**Master Development Drainage Plan
For
THE RANCH**

November 2018

SKP-18-006

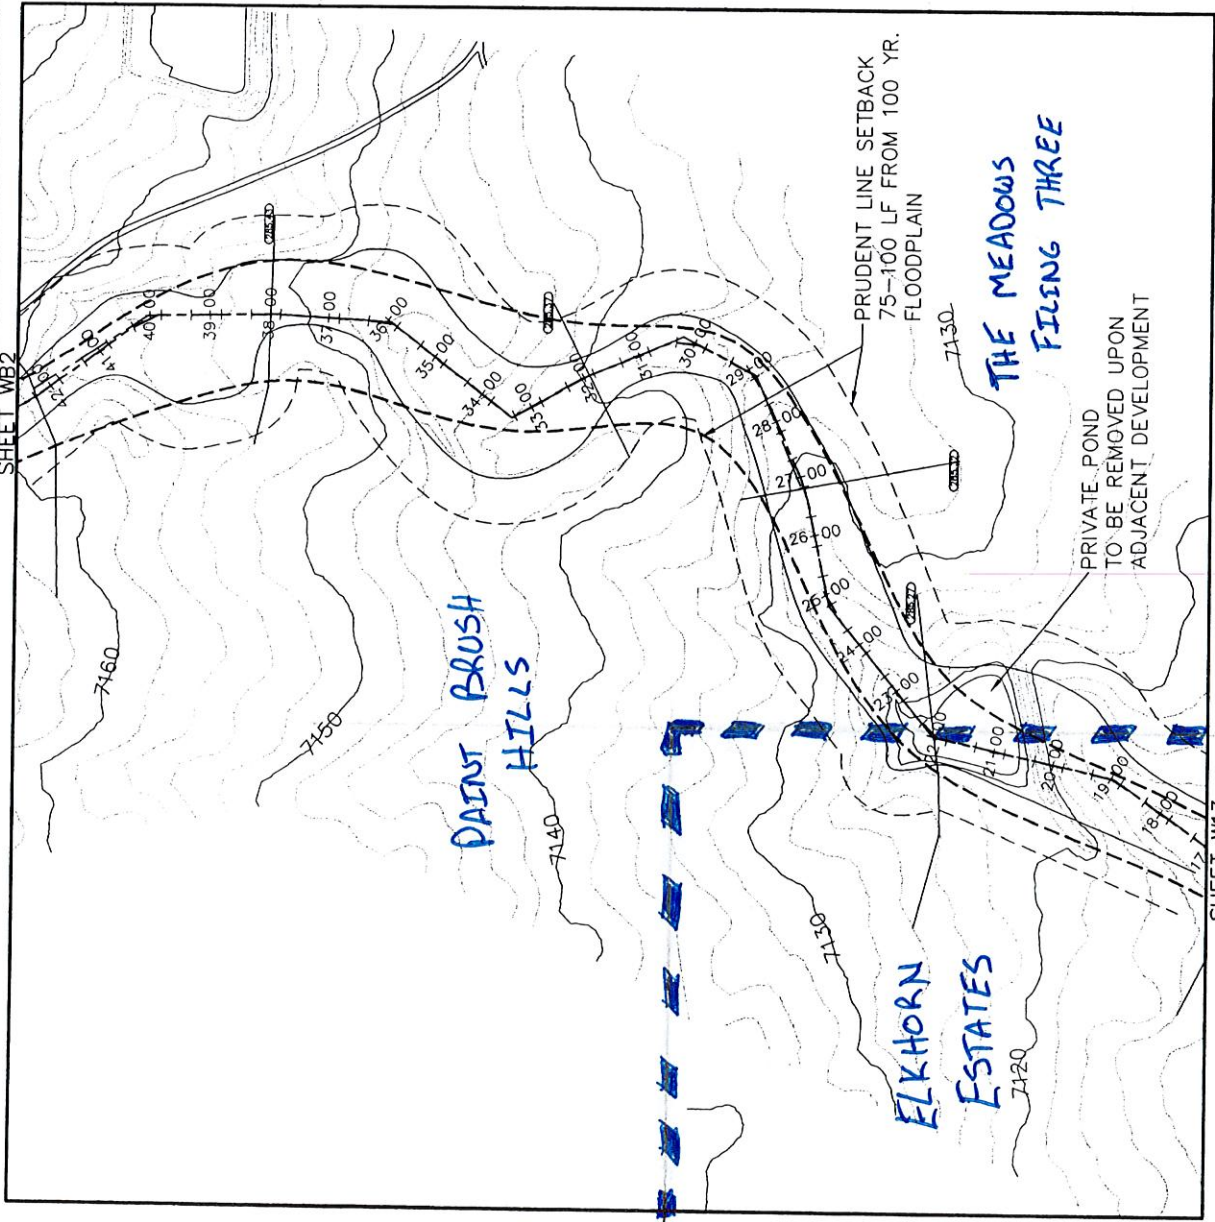
Provide excerpts from the new DBPS.
